ProTech GII, TPS, and MSM User Configuration Guidance

Service Bulletin 01671 p.2

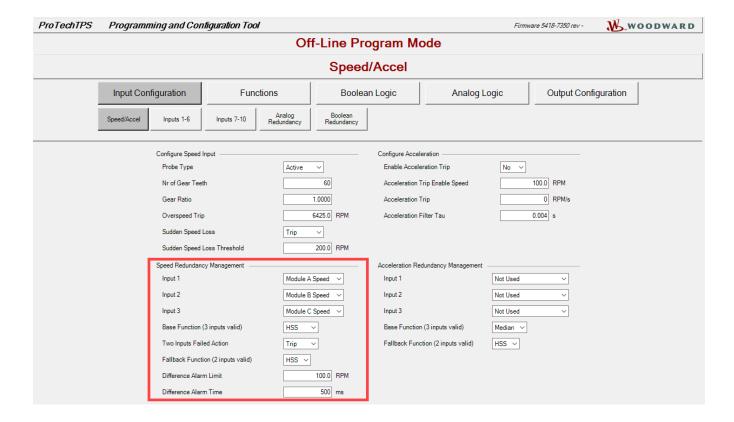
It is recommended that on ProTech TPS or MSM products, the option Speed Fail Trip always be set to "Used" whenever the configuration of the speed input probe type is "Active". If this is not desired, due to a need to have other Safety Instrumented Functions (SIF) protected in all 3 kernels, then use the "Speed Redundancy Management" option and configure both "Base Function" and "Fallback Function" to be HSS.

It is recommended that on ProTech GII products, the option Speed Fail Trip always be set to "USED" whenever the configuration of the speed input probe type is "Active".
